Reviewer #3

We thank you for reviewing our manuscript and for the constructive comments you gave. We appreciate your efforts a lot, as they helped us to improve our work. The following tables list our responses to your comments.

Jacob Hardt et al.

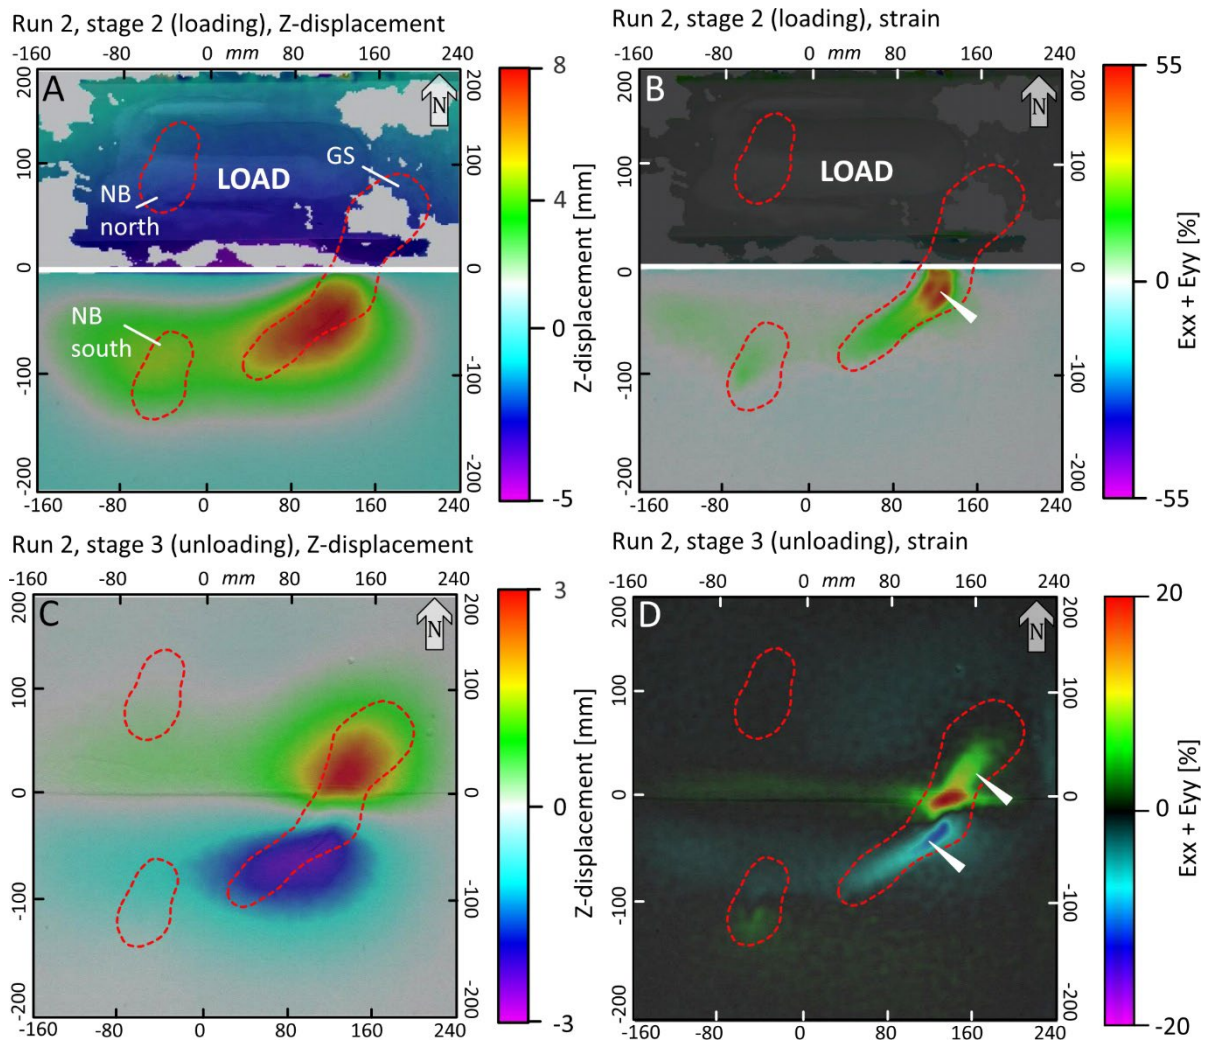
<p>The 'Experimental methodology and setup' section starts with 'Remarks on the selection of model parameters' followed by 'Modeling materials and data capture' and finally 'Model design'. I suggest that the 'Remarks' section be moved to the end because the reader cannot necessarily relate to remarks on the individual stages of the modelling before the model has been described. Also, consider moving the sentences of lines 185 to 193 to the end of the 'Remarks' section as it, in my opinion, fits better here.</p>	<p>Thank you! We agree and followed your advice!</p>
<p>In the 'Results' section you mention the crestal grabens that form above the modelled salt structures. As the figures generally are small, please refer more specifically to where on the figures the crestal grabens can be seen (i.e. with arrows).</p>	<p>Done! We've added white arrows to the respective images and added a note on that in the text and in the figure captions. (see below)</p>
